Technical Bulletin

DP02	TB0021-2007	Elan Motorsports Technologies	
From:	Chip Lewis		
Subject:	<i>Nose Blanking Panel Option</i>	Date:	October 10 th , 2007

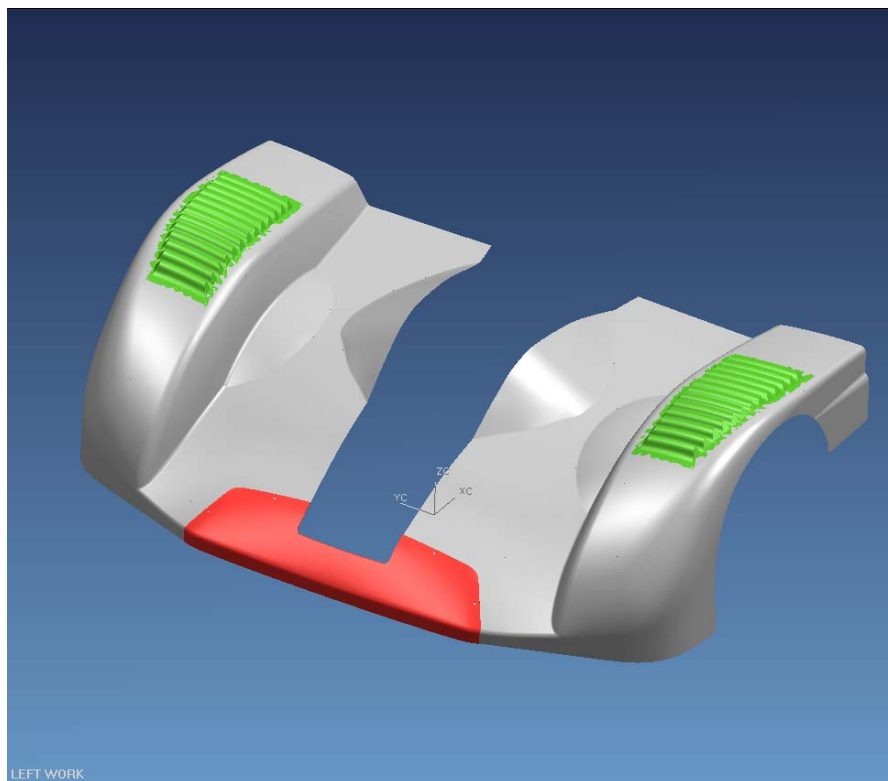
Available to order is an optional nose blanking panel, Part No. DP02-40-047. The nose blanking panel is expected to help raise coolant temperatures on cold days. The nose blanking plate has an optional scribe line that teams can use to trim the plate for additional cooling. An assembly that includes the panel and mounting hardware can also be ordered, ADP02-40047.

Note: *This nose blanking panel is a homologated component and is the only version that can be used.*
